Perimeter Boxing Type Location Level 06
1 : 200

PROJECT STATUS	RIBA STAGE 5
CLIENT	Manchester City Council
PROJECT	OUR TOWN HALL
DRAWING TITLE	Perimeter Boxing Type Location Level 06
SIZE & SCALE	A1: 1 : 200
DRAWING STATUS	FOR CONSTRUCTION
JOB NUMBER	236959
DRAWING NO.	OTH-PUR-TH-06-DWG-A-0607
REV	09

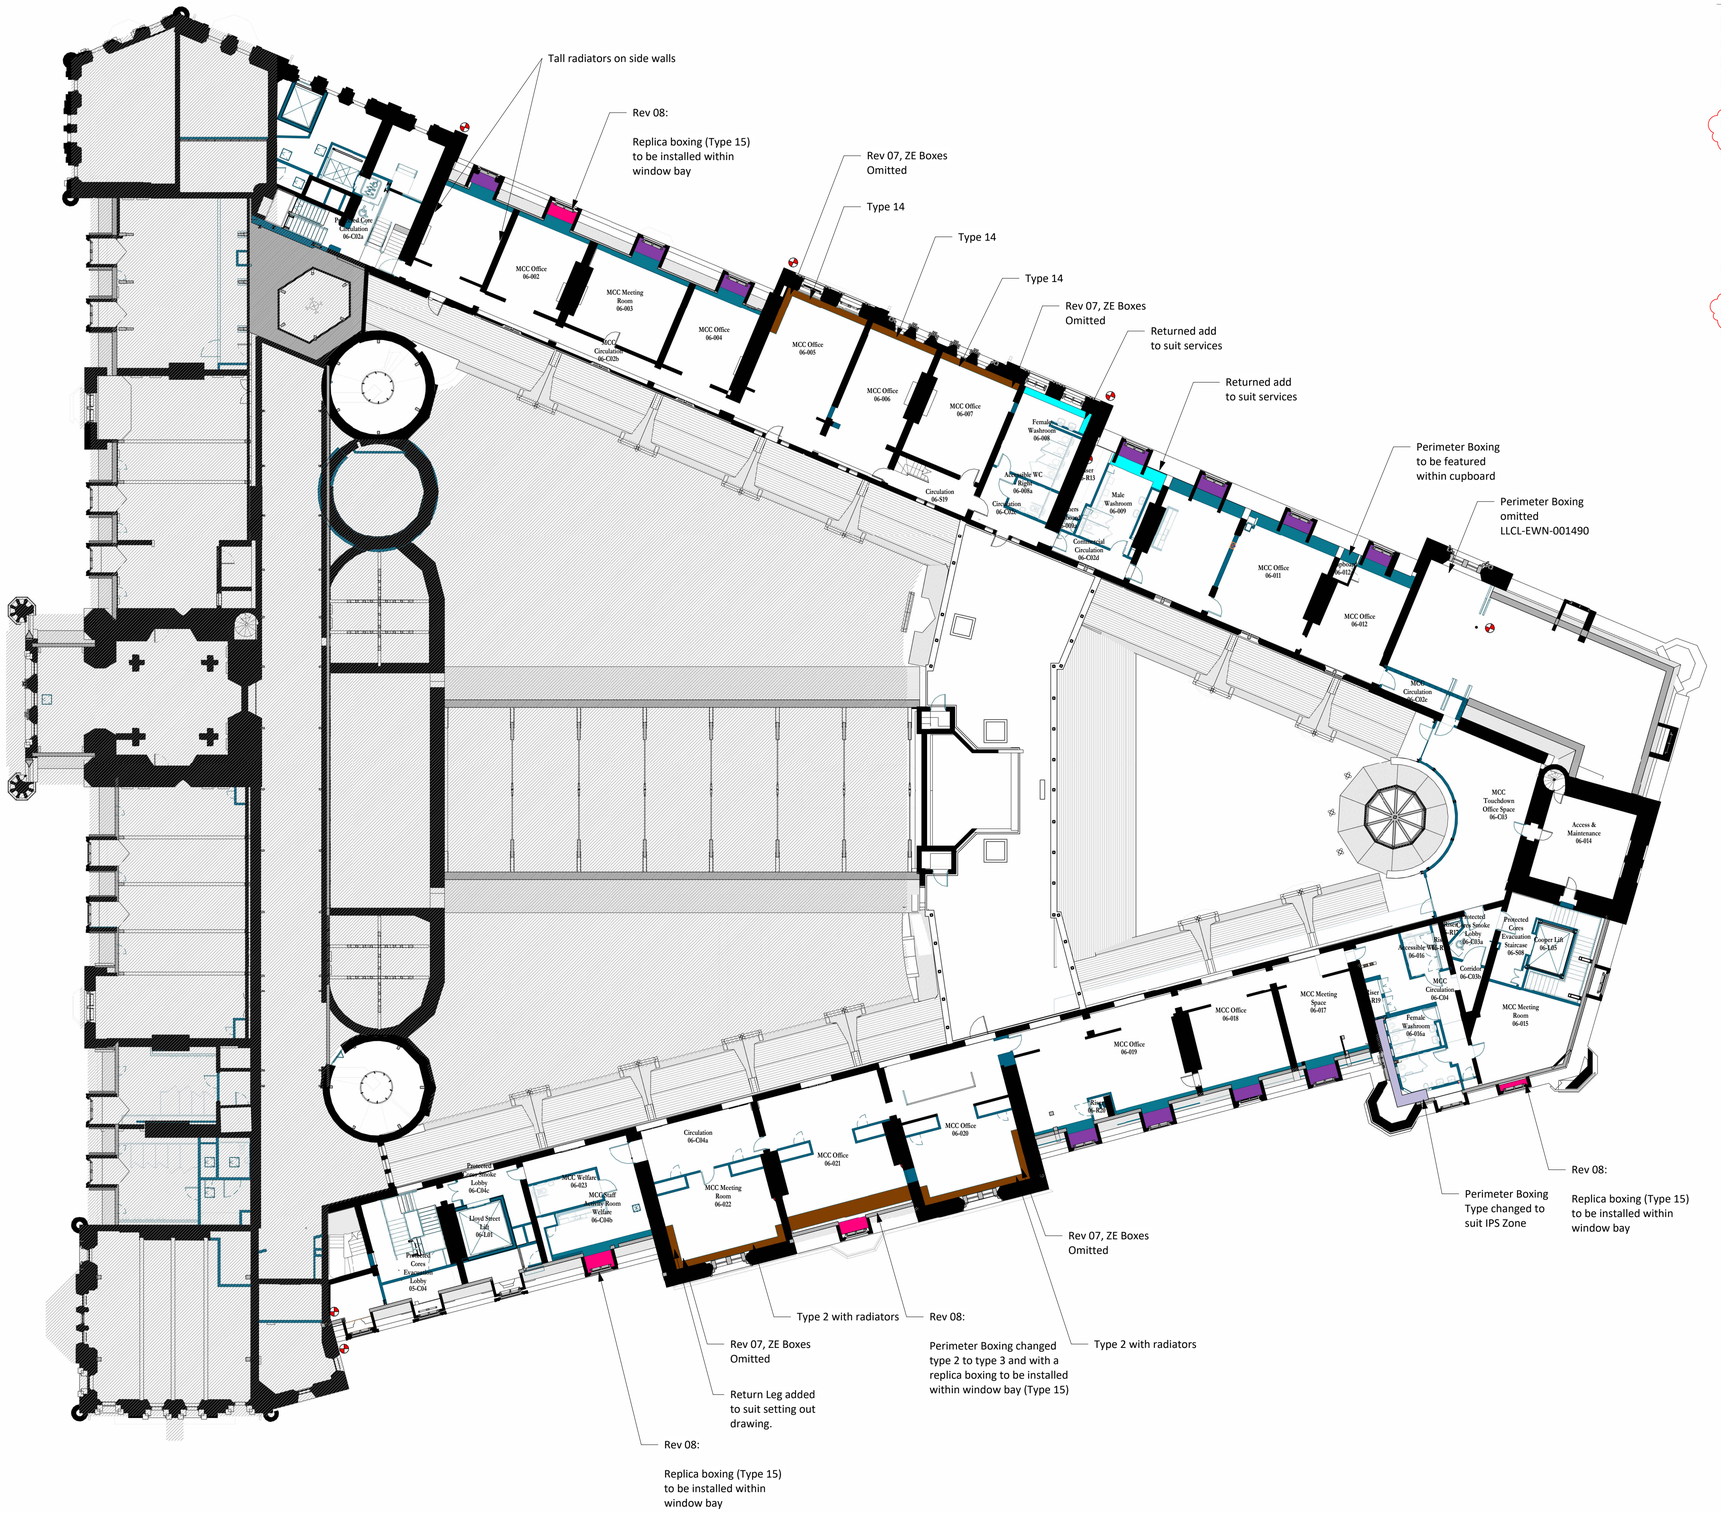
Revision 08:
1. Perimeter boxing depth and height adapted to suit ARUP amendments to services layout, refer to drawing OTH-PUR-TH-ZZ-DWG-A-5922
2. Perimeter boxing to room 06-021 changed from Type 2 boxing to Type 3 boxing due to the position of the roof access hatch.
3. Perimeter boxing in room 06-015 omitted due to constraints within the room.
